## SERVICE BULLETIN

ENGINE - HP COMPRESSOR - REWORK THE FUEL FLOW DIVIDER MOUNT BRACKET ASSEMBLIES TO  
PROVIDE ADDITIONAL TOOL CLEARANCE - CATEGORY CODE 6 - MOD.ENG-72-0078

# V2500-ENG-72-0078

Location of the 2A1903-01 fuel flow divider valve bracket assembly  
Fig.1

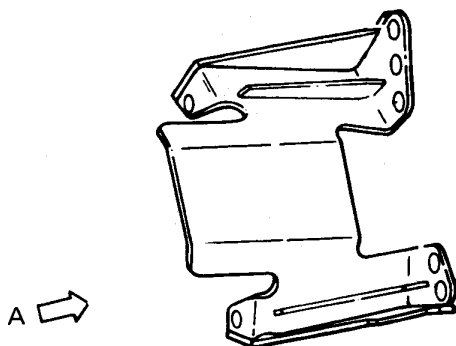
- (1) Do a modification to the 2A1903-01 Fuel Flow Divider Valve Bracket Assembly (1 off) (See Reference (1), 72-40-00, Fig/Item No.01-260) and identify as follows:

Procedure	Supplementary Information	
(a) Set-up and machine the Fuel Flow Divider Valve Bracket Assembly to the dimensions specified	Refer to Figures 1 and 2, requirements	
(b) Mark the new part number adjacent to the old part number. Use the vibration peen method	Old Part Number	New Part Number
	2A1903-01	2A2073-01
	Refer to Reference (2), Control No./Task No.70-09-00-400-501

Modification of the 2A1903-01 fuel flow divider valve bracket assembly  
Fig.2

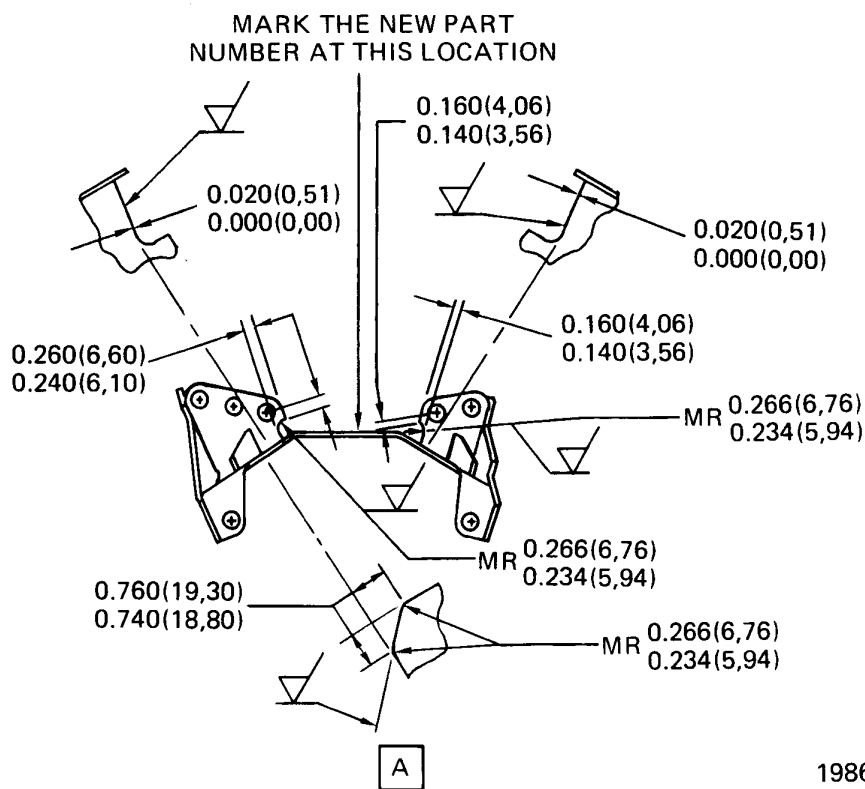
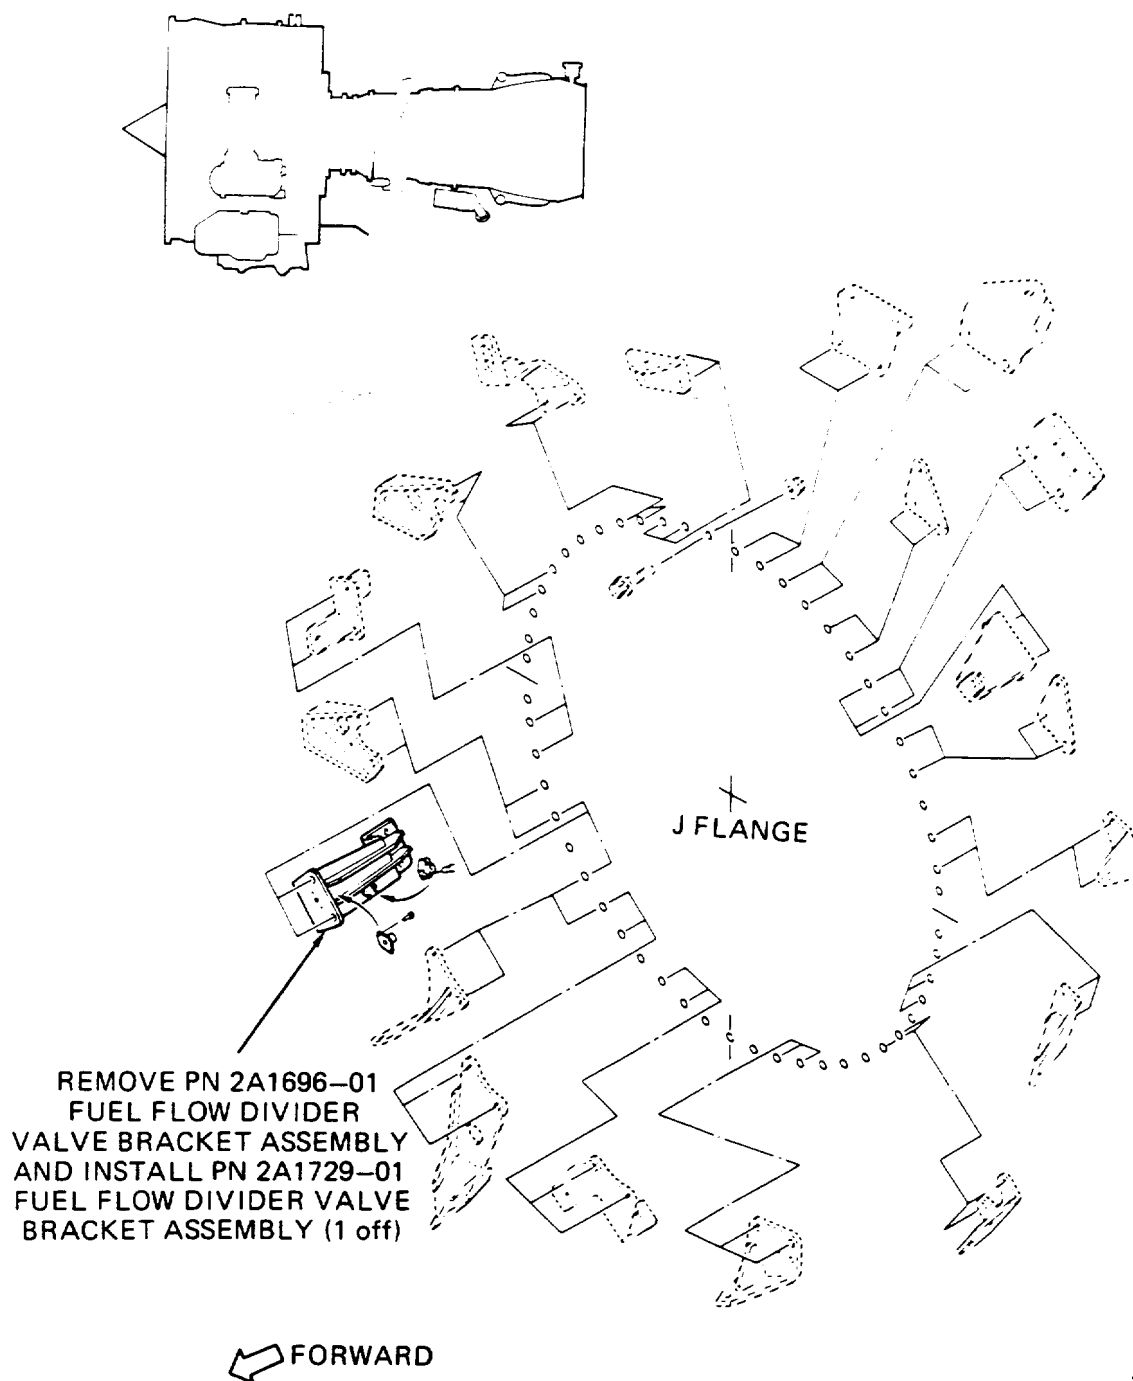
- (1) This change provides configuration modifications of Front and Rear Fuel Flow Divider Valve Bracket Assemblies. The modifications give additional clearance for the Seventh Stage Bleed Valve Retention Bolts and will permit the Rear Bracket Assembly to rest in its correct position, when mounted on the flange.

Modification of the 2A1696-01 fuel flow divider valve bracket assembly  
Fig.4

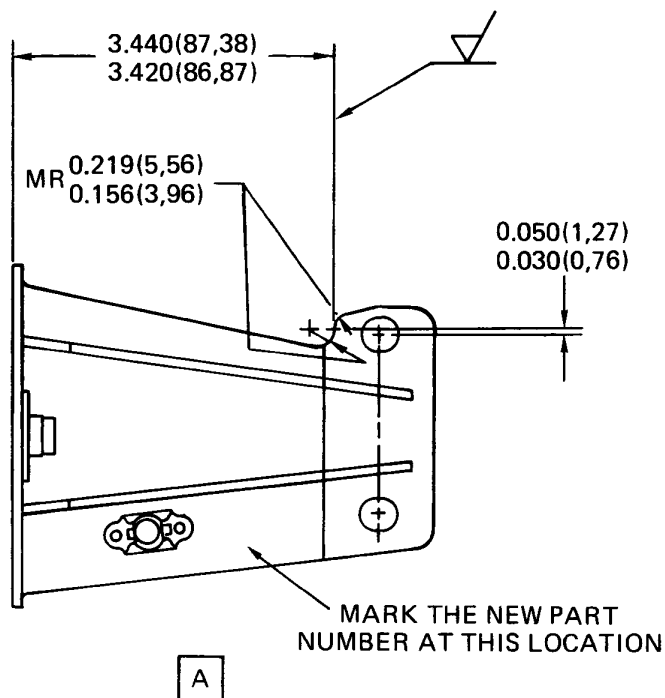
- (2) Do a modification to the 2A1696-01 Fuel Flow Divider Valve Bracket Assembly (1 off) (See Reference (1), 72-41-00, Fig/Item No. 03-400) and identify as follows:

Procedure	Supplementary Information	
(a) Set-up and machine the Fuel Flow Divider Valve Bracket Assembly to the dimensions specified	Refer to Figures 3 and 4, requirements	
(b) Mark the new part number adjacent to the old part number. Use the vibration peen method	Old Part Number	New Part Number
	2A1696-01	2A1729-01
	Refer to Reference (2), Control No./Task No.70-09-00-400-501
